**PROPOSED RESIDENTIAL CONVERSION OF LISTED BARNs AT BEAUMONT HALL**  
**Application Ref. 19/01346/FUL & 19/1347/LBC**

**STATEMENT ON AMENDED DESIGN**

Including additional information on proposed insulation of historic building fabric.

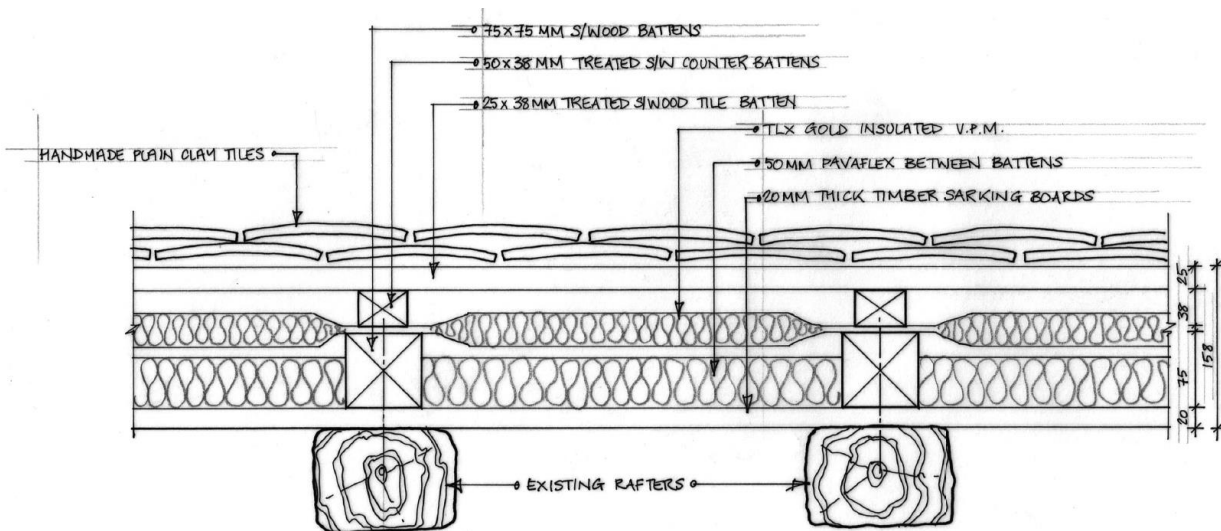
Where the brick walls must be insulated, again this will be done using a breathing system such as Thermalime or a lime hemp render applied to the internal face of the walls. Conventional application of modern PIR insulation between timber studs on the inside face of historic brickwork has been shown to result in damp walls, and so we prefer to keep to a breathing system. The extent and final detail of this will be subject to negotiation with building control.

ROOF Horizontal Section  
TYPICAL DETAIL FOR EXPOSED ROOF FRAME

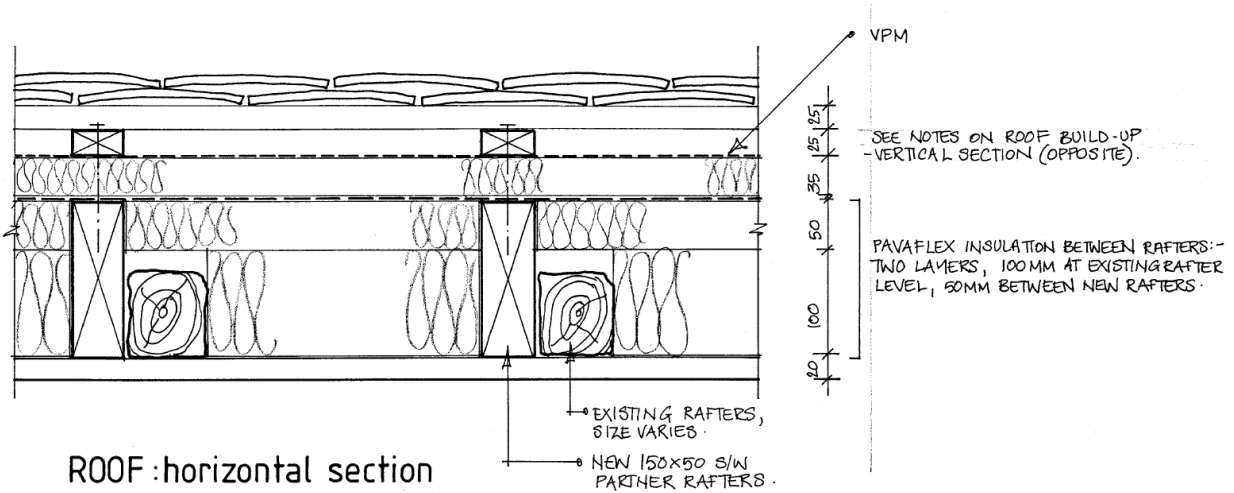
The detail below has been developed for the insulation of roof frames on other barn conversions in Essex, and approved for use on listed buildings. It shows the historic roof frame fully exposed, with a build-up of layers of boarding, wood-fibre insulation (Pavaflex) and the use of a vapour permeable multi-foil insulation (TLX Gold).
